LAWRENCE BERKELEY NATIONAL LABORATORIES FACILITIES DIVISION						
Scale: 1/8" = 1'-0"	Sheet no: S2.0	Project No: 6947816	Project ID: FNO100	Original sheet - A01	Drawn by NAL Date 11/14/2011	Checked by JRW Date 11/14/2011

REQUEST FOR INFORMATION

INFORMATION REQUESTED BY: Keith Mohler RFI #: 17

PROJECT: User Test Bed DATE: 12/12/12

1 GROUND FLOOR FRAMING PLAN
1/8" = 1'-0"

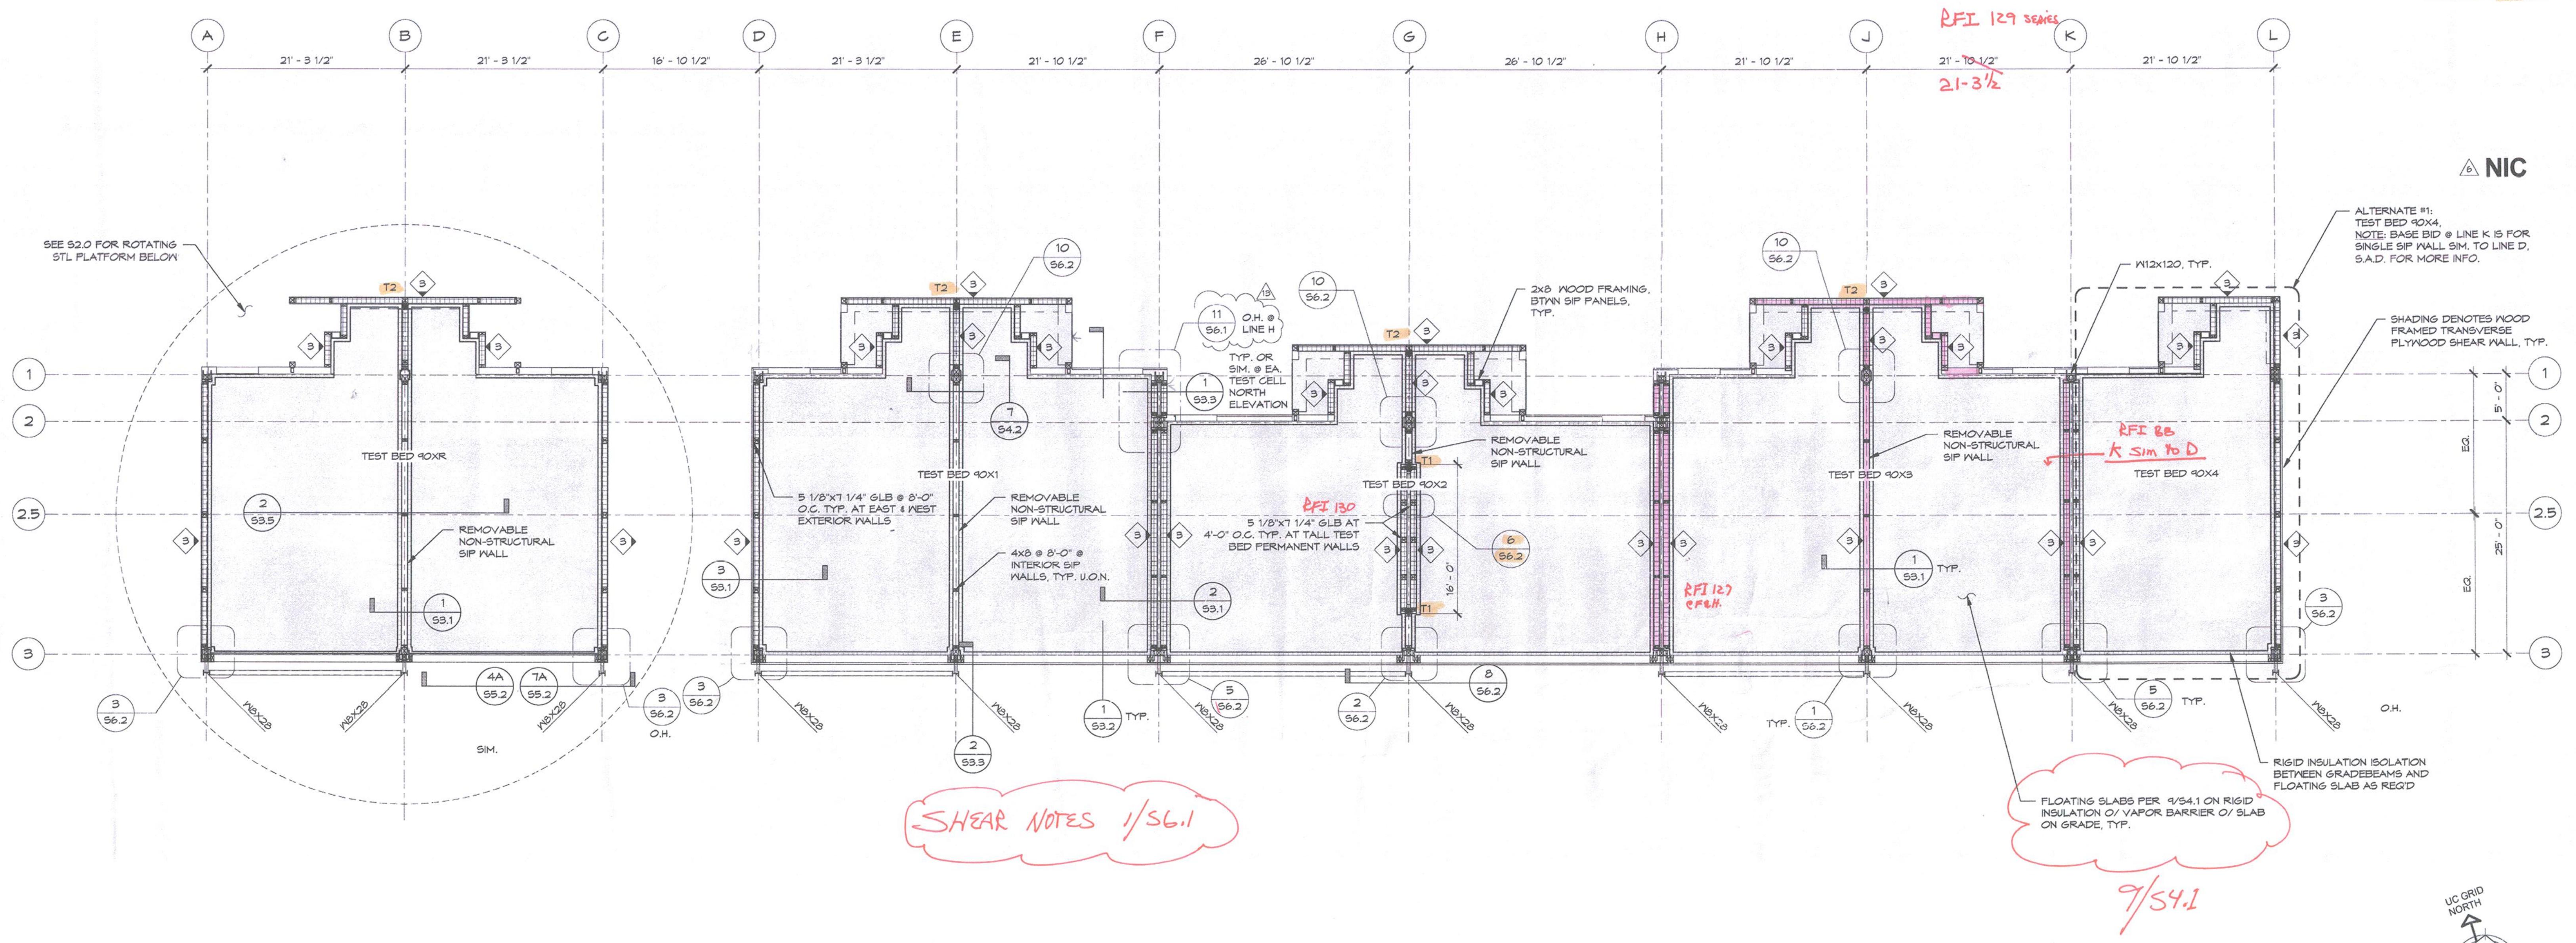
24' maximum SIP panels -

At the tall test bed 90x2 at the permanent SIP panels on Grid G - detail 2A & B/S6.2 indicate that SIP panels to be continuous height.

SIP manufacturers maximum height of panel is 24'-0" and the permanent panels on Grid G will exceed 24' maximum. Upper and lower panels can be joined at future floor height with 6 3/4 x 10 1/2 GLB at full height vertical 5 1/8 x 7 1/4 GLB panel splices similar to detail 20/S6.2. The 6 3/4 x 10 1/2 horizontal GLB at future floor line will also take the place of the internal 3x10.

Will this be acceptable?

Regarding the permanent portion of the tall interior wall at line G, the proposed joint at wall mid-height is not acceptable because it will form a hinge at the wall mid-height when the intermediate floor is not in place. As shown in details 2A & 2B/S6.3, the design intent is for the vertical glu-lams at 4'-0" on center to extend the full height to underside of floor above. This will be acceptable when the intermediate floor is not in place. SIP panels to be tall, fit between the taller continuous vertical glu-lams and the filler panel (no taller than 3 feet), with a horizontal blocking spine between vertical glu-lams, similar to 1C or 1D/S6.1 except the spine members are long blocks between the vertical glu-lams. If detail 1C is used (two x spines interlaced), the project inspector shall verify that internal gluing is properly installed before the filler panel is placed that conceals the interlocking. John Wolfe, Tipping Mar, Jan 14, 2013

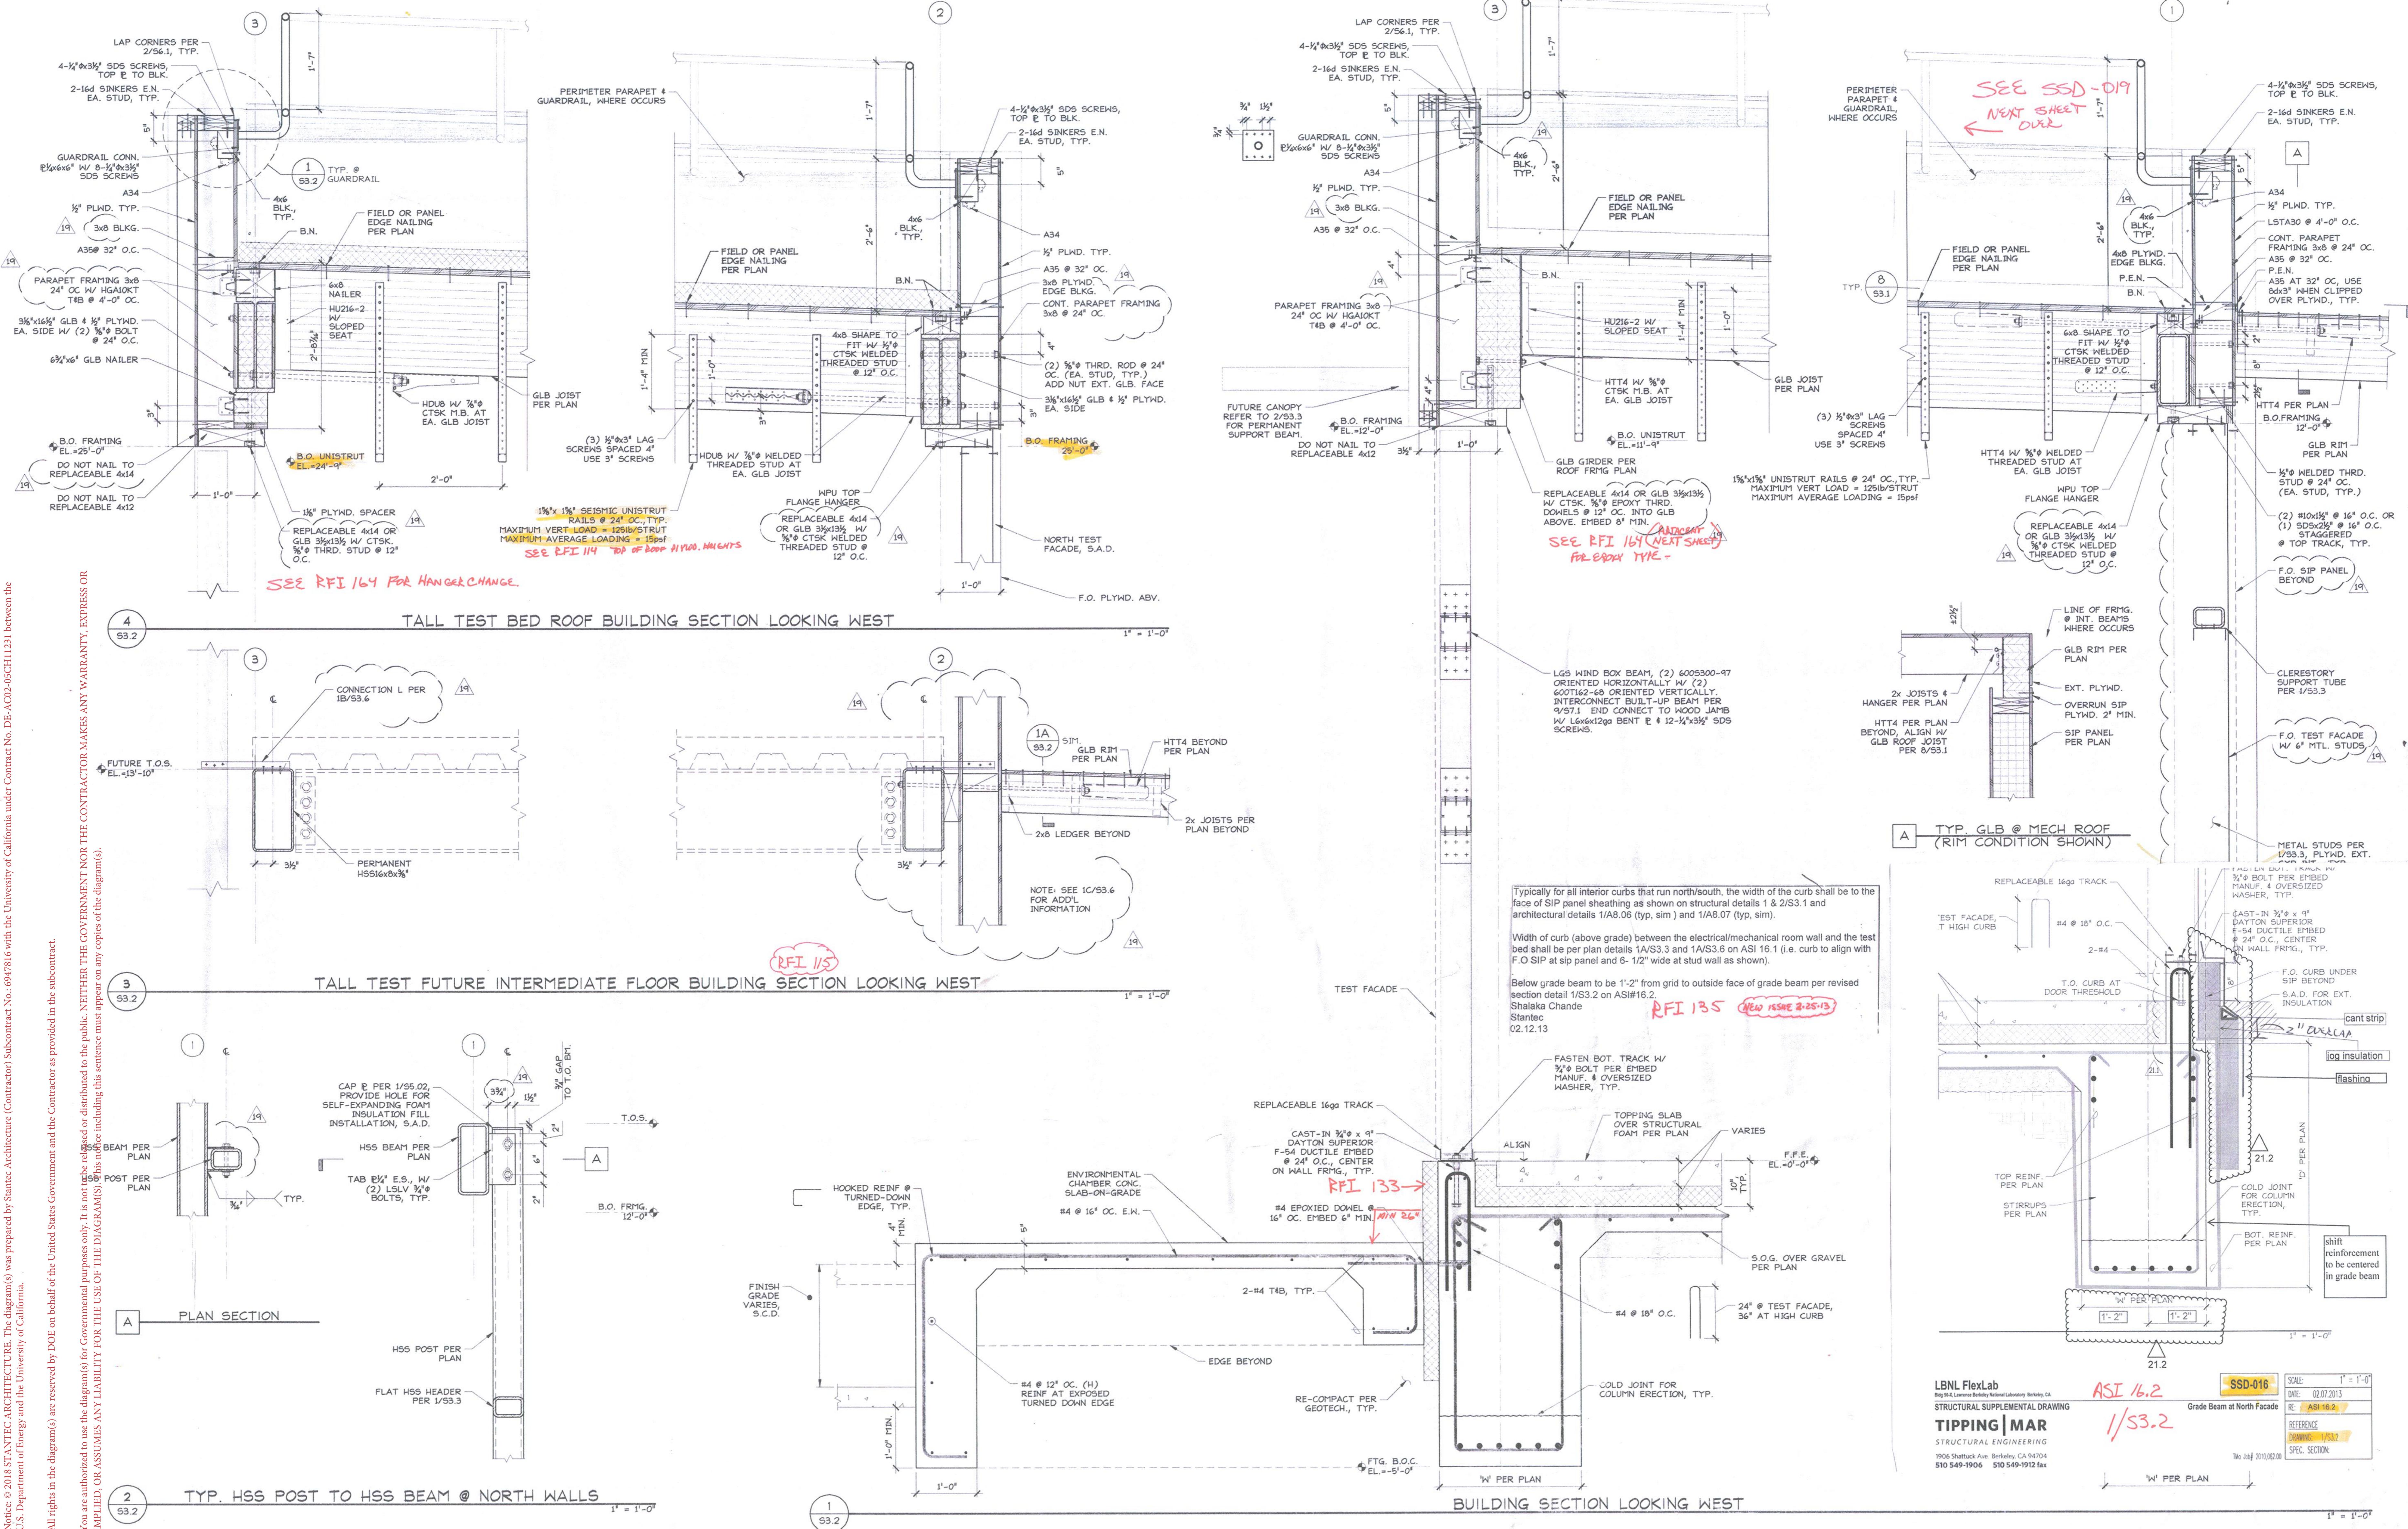
1) The wind box beams shown on 1/S3.2 reference you to 9/S7.1 for the end connections?
 2) Detail 9 on S7.1 is for headers greater than 5 feet?
 3) Per the response given in RFI # 232 the clips that are shown per detail 9 on S7.1 can be 2 $\frac{1}{2}$ " \times 16ga" x 2 $\frac{1}{2}$ " \times 16ga" x 5-1/2" x 16ga?

4) If detail 9 on S7.1 does not apply to the full-width header or for the end connections please provide a note for the location?
 1. No, as the note on 1/S3.2 states, "Interconnect built-up beam per 9/S7.1. End connect to wood jamb w/...etc." Detail 9/S7.1 is only referred to the screw locations to interconnect the built-up stud and track sections, not how the end connects to the wood jamb. Because the stud and track sections are so thick, use #12 sheet metal screws (SMS) instead of the #8's called for on 9/S7.1.

2. As far as the end connections are concerned, the detail applies to headers more than 5 feet long but less than or equal to 10 feet long (as stated in our previous response).

3. L2x2x16ga clips are ONLY for headers up to 10 feet long (e.g. at north facade). Does NOT apply to the south facade wind box beams.
 4. Refer to the last portion of the note on 1/S3.2: "End connect to wood jamb w/ L6x6x12ga bent plate & 12-1/4"X3.5" SDS screws." Clarifying information: L6 clip is at top and bottom of each end of wind box beam, with 12-SDS screws total per end of the wood beam, 8 at top clip and 6 at bottom clip, as graphically shown on 1/S3.2. Connect each L6G clip to the top and bottom of the wind box beam with 6 - #12 SMS. Pre-drill clips with 5/16" holes for the SDS, and 1/4" holes for the SMS; locate edge holes 1.25" from clip edges.

HEADER AT OPENING GREATER THAN 5 FEET

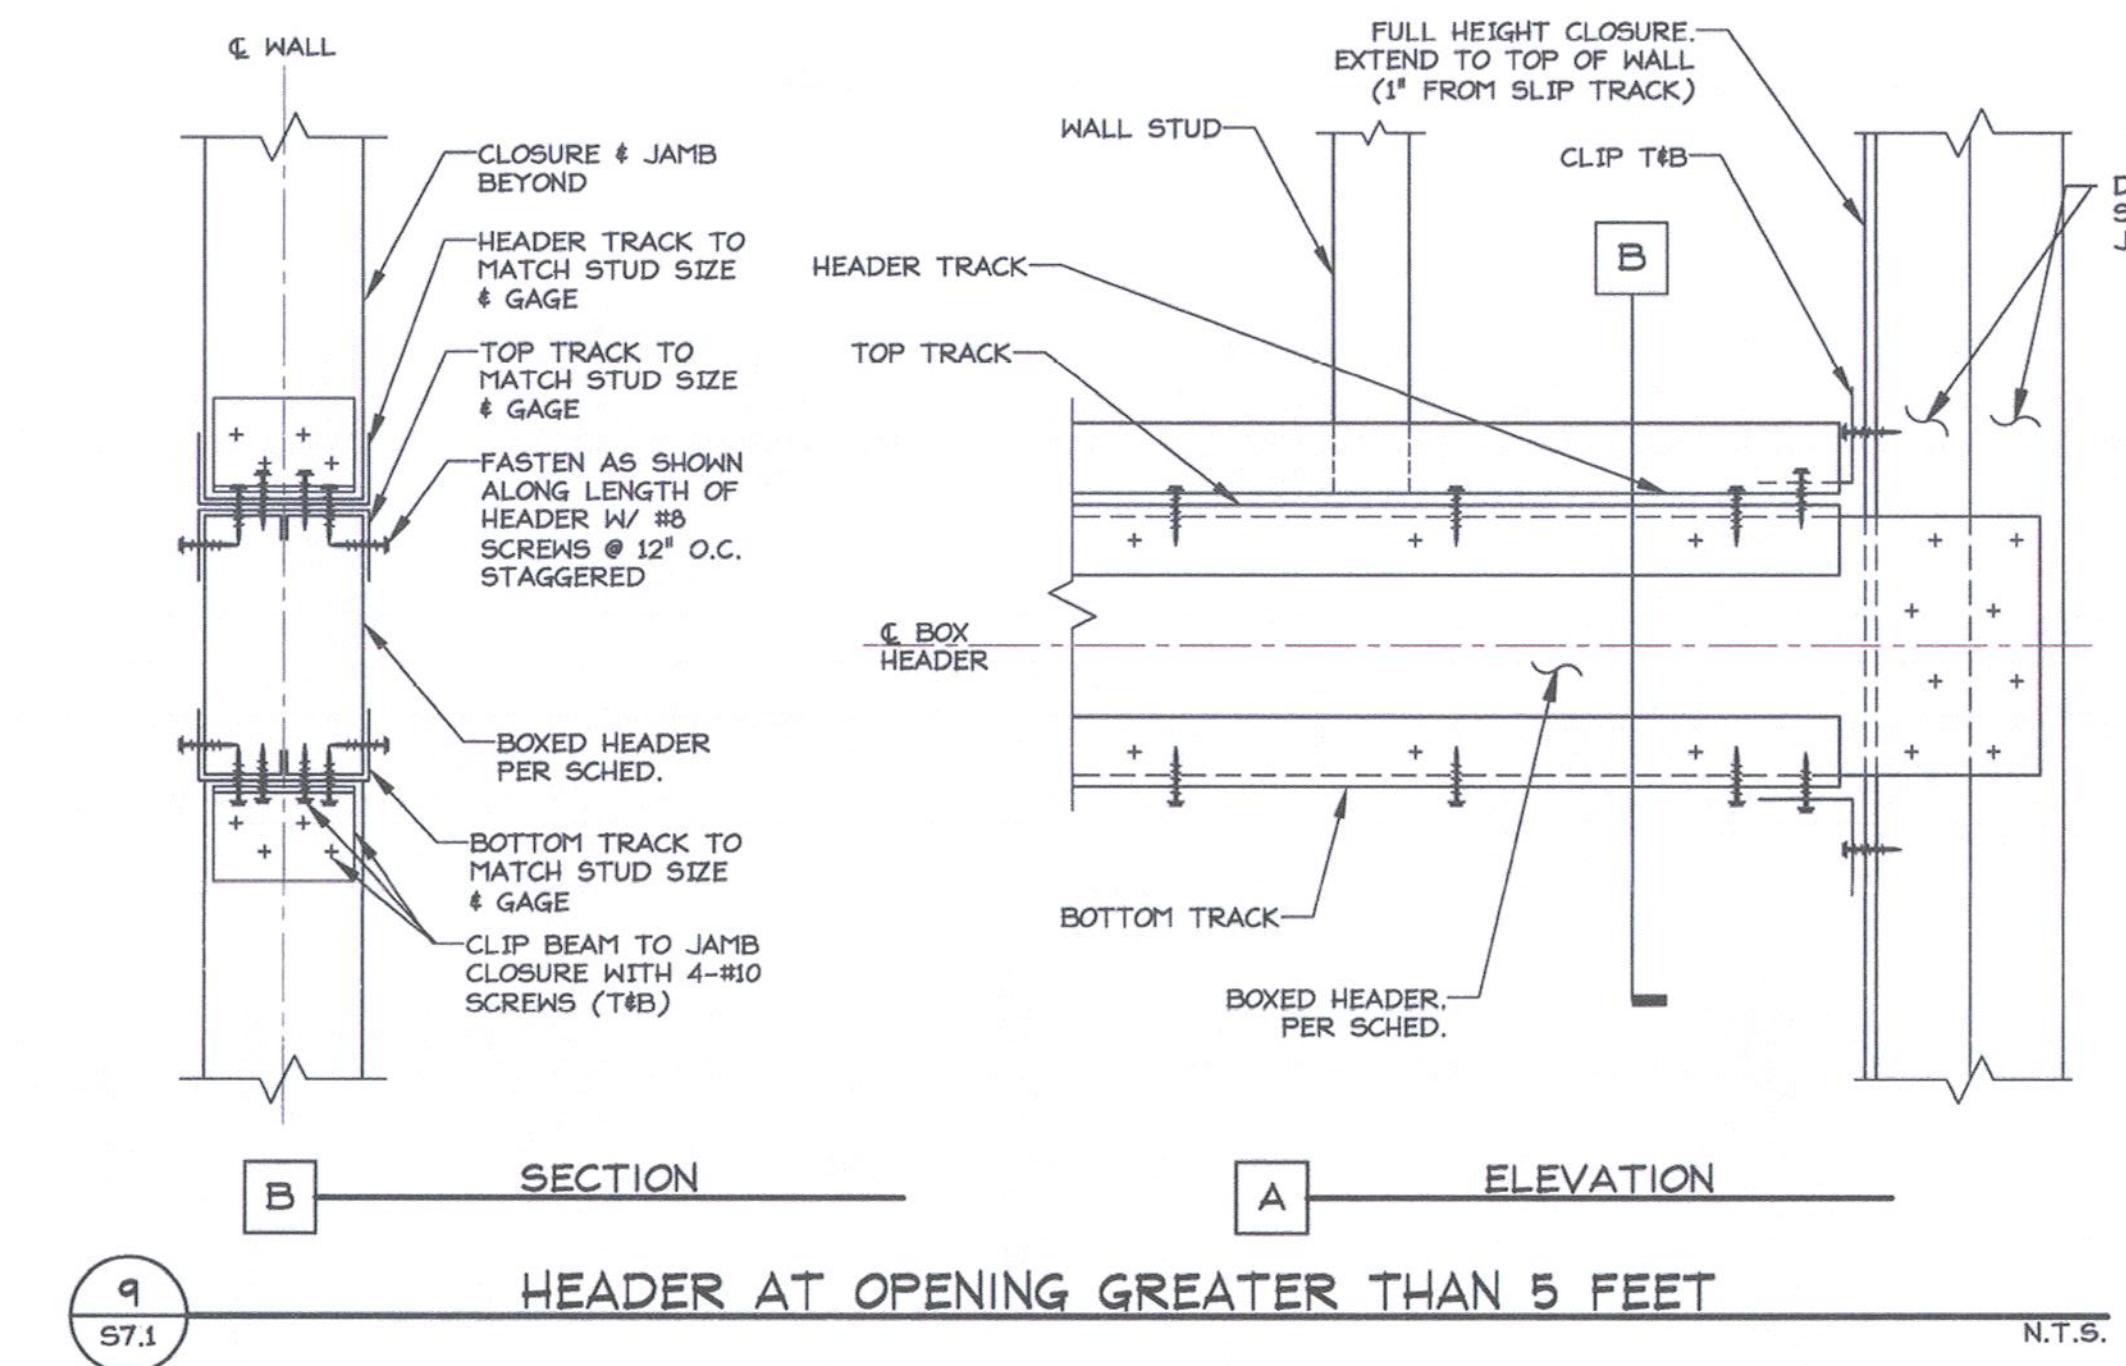
RFI 232 - S7.1

A 2"x2" x 16 ga clip is acceptable. The length of the clip should be no shorter than the width of the stud minus 1/2".
 Please note that detail S7.1 only applies to openings ten feet or less in width.
 Moreover, please note that S7.1 does NOT apply to the full-width headers ("wind box beams") shown on 1/S3.2. Those box beams on the south facade are continuous across the full bay width of each test cell, and have special end connections as called out on detail 1/S3.2. The studs below and between those box beams bear the weight of the facade and should therefore have standard tracks, not slotted deflection tracks.
 John Wolfe, Tipping Mar, July 9, 2013
